69-F-69

CONTRACT 68-123

H.W.Y. #516 (FAILURE)

Failure of Hwy. 516 at Utterson Lake
Contract 68-123 -- W.J. 69-F-69

STA. 123 + 50

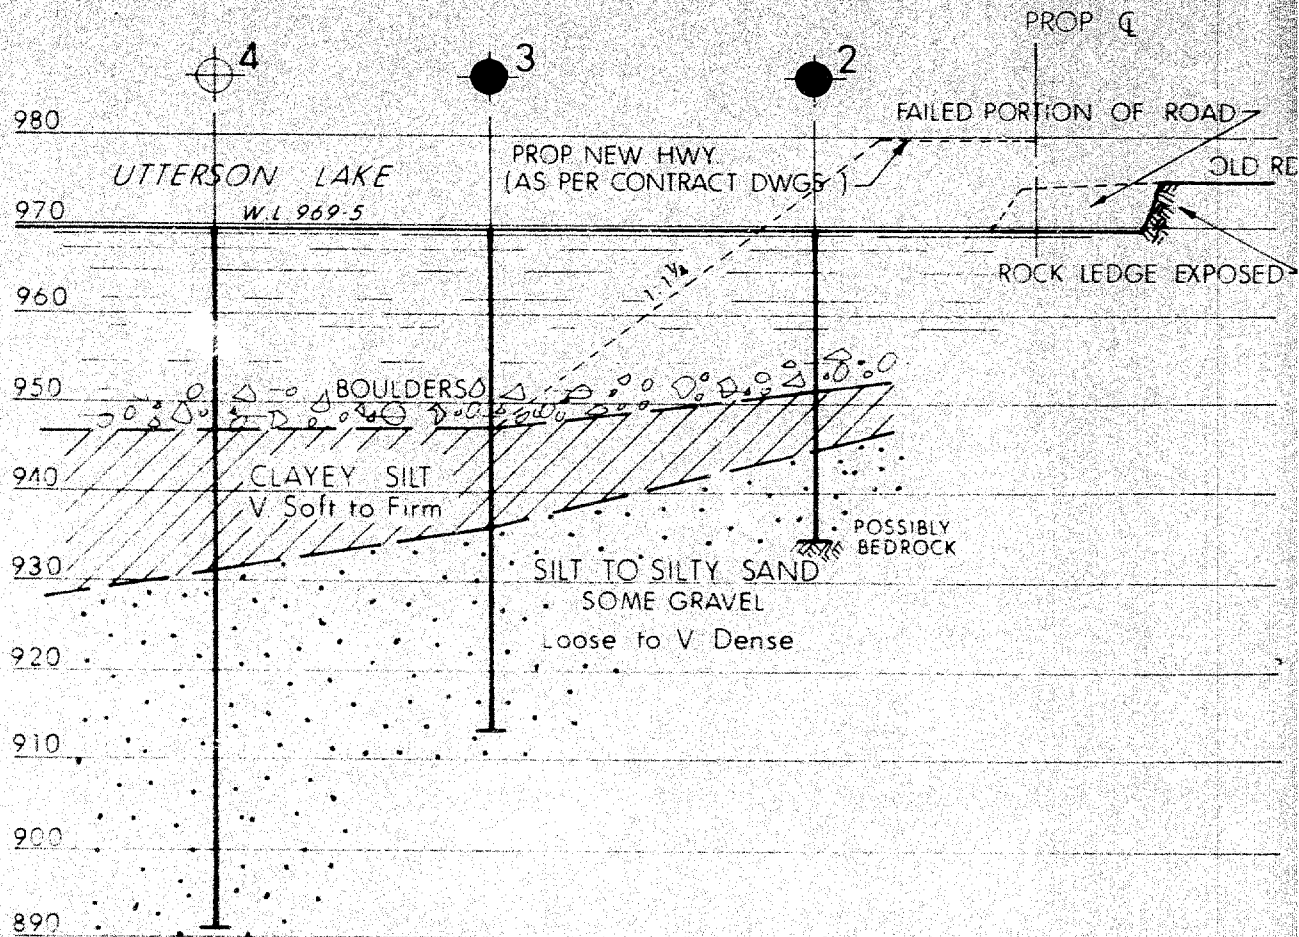
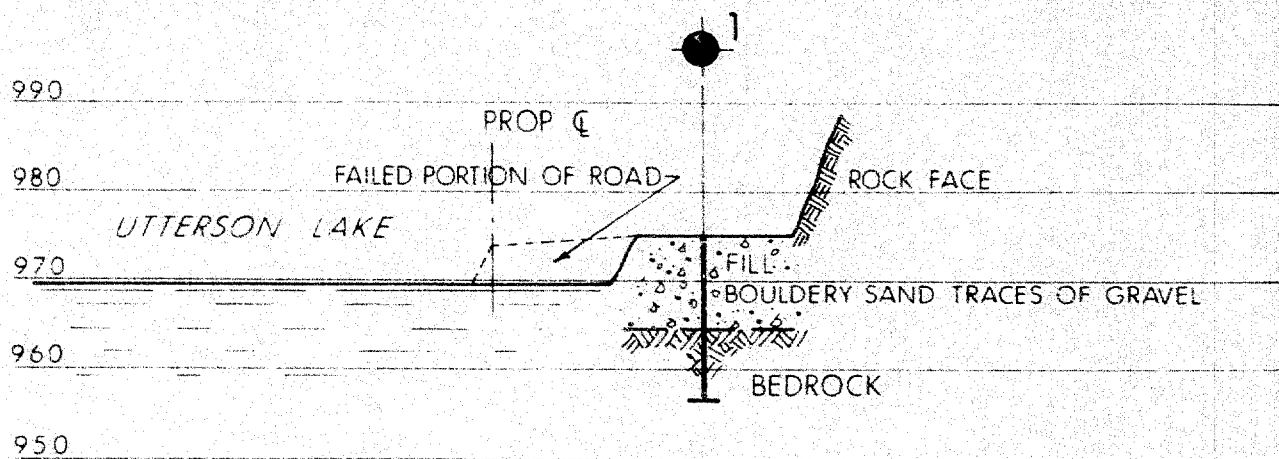
Subsoil was found to consist of from 7 to 15 feet of very soft to soft clayey silt followed by 20 to about 40 feet of loose to very dense silt followed by granite bedrock. The thicknesses of the subsoil layers increase with increasing distance into the lake from the edge. Along the boundary of the failed zone a rock ledge was observed to extend from the east end of the zone to about Station 123+15. At this point B.H. #1 revealed that the rock was about 10 ft. deep, indicating that the projecting ledge was sloping steeply downwards from a point just east of Station 123+15.

Failures have occurred by displacement of the soft clayey silt subsoil referred to on the foregoing page. Shock waves from blasting, and the impact loads of large quantities of blasted rock have been the cause of the failures. This type of failure is likely to reoccur in the future until all blasting work is completed, or until all of the soft material is displaced.

With regard to the future construction and subsequent performance of the section of highway involved, it is our opinion that a satisfactory road can be built along the line as originally designed, though of course it would be preferable to move the line as far south into the rock as is possible. In any event, all future fills which overlie the soft material should be built initially several feet higher than the final grade. The object here is to ensure that the embankment portion will be subjected to greater loads during construction than after construction, in which case, it can be assumed that a reasonable safety factor will have been achieved. The method of placing fill, therefore, should be designed so as to achieve this objective.

With regard to the future performance of the road, it is likely that cracking will occur over the boundary between the above mentioned rock ledge and the embankment fill. It is difficult to see how this eventuality can be avoided, however, and it must be accepted as a continuing maintenance problem which may decrease with time.

CONTRACT 68-123
SIDE HILL CUT AT
LONGS LAKE

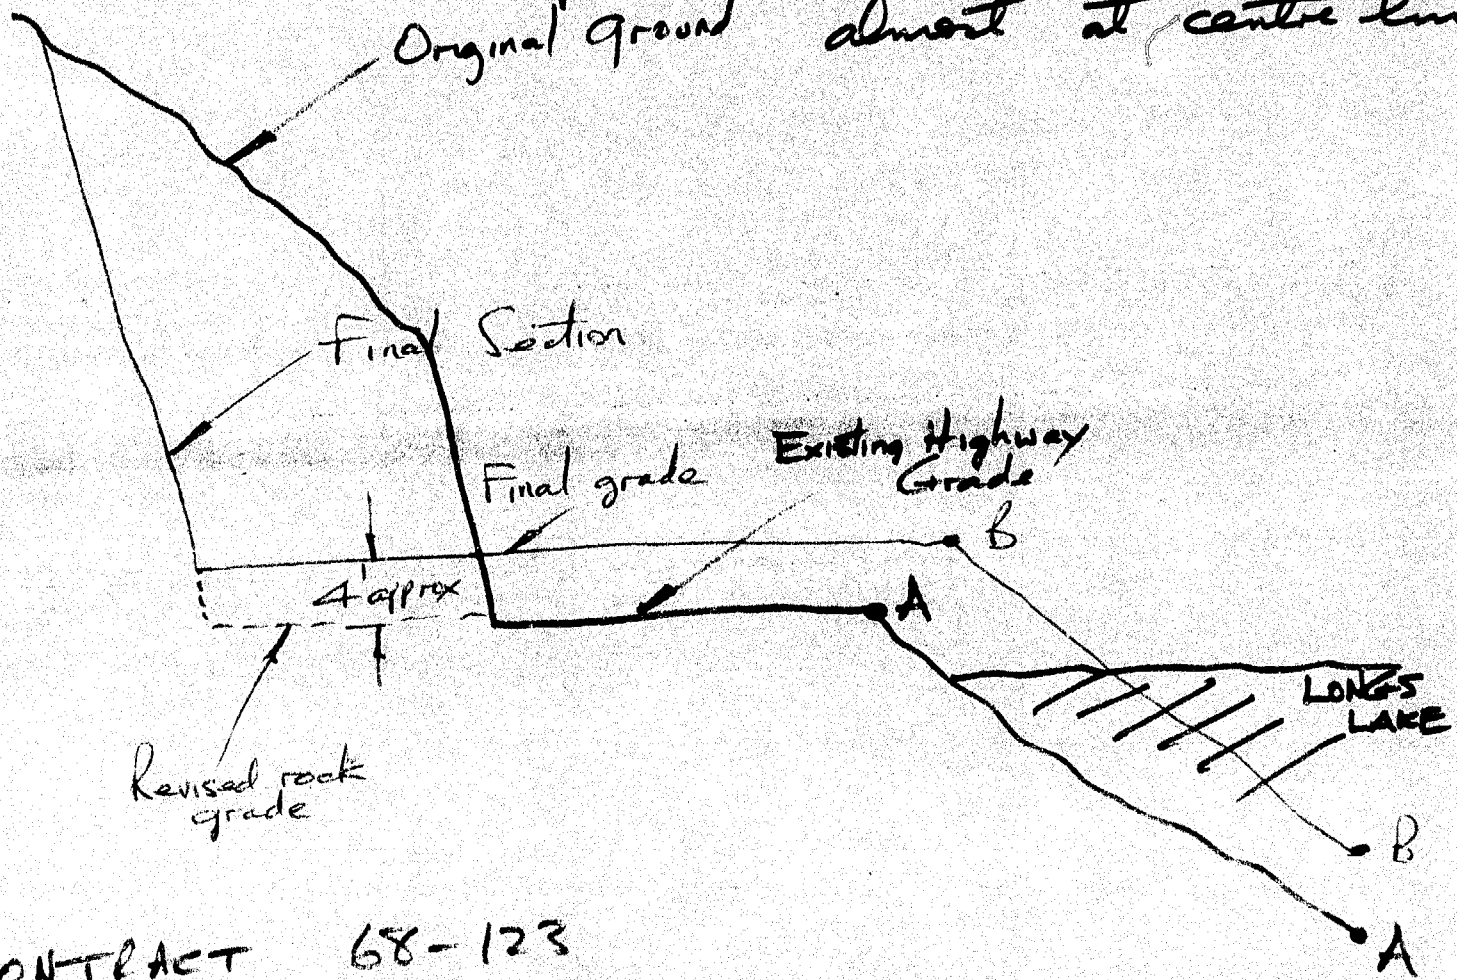
It would be very useful if the slope of the line A-A would be known. It is realized that, because of the water, it may not be easy to establish that. However, the knowledge of the slope at the "worst" locations would enable us to decide whether the building of a berm is necessary and feasible. The berm could be built by just dumping and pushing the material over the slope, or by overbuilding and thus inducing a failure.

- a) I have discussed with Tony Stermac the possibility of a future failure of fill material along rock face A-A. Mr. Stermac's opinion is that this is impossible to predict, and his advice is that we proceed in accordance with our plans and keep a watch on the situation. I agree with his recommendation.
- b) We have requested the Contractor to blast several short sections of the cut rather than take out all of the rock in one or two blasts. Our reasons are twofold, namely:
 - (i) One or two large blasts could, we feel, result in a large amount of rock kicking into, and being lost in, Long's Lake, beyond the proposed fill slope B-B.
 - (ii) We are not at all certain that mucking could be completed in 48 hours. Detouring would be complex, and

NOTE At the "worst" location the line A-A produced intersects the new grade almost at centre line.

1. Rock grade for the length of side hill cut from approximately station 124+50 to 127+50, will be lowered by some 4' so that final rock grade will be at the elevation of the existing highway. This will give us a more uniform roadbed and will make available rock which is badly needed for widening on the lake side.
2. Should still more rock be required for widening, we will establish a rock borrow item.
3. We will investigate the possibility of lowering profile grade through this section of the project, however, if that is not feasible, we will build up from the existing highway elevation with borrow.
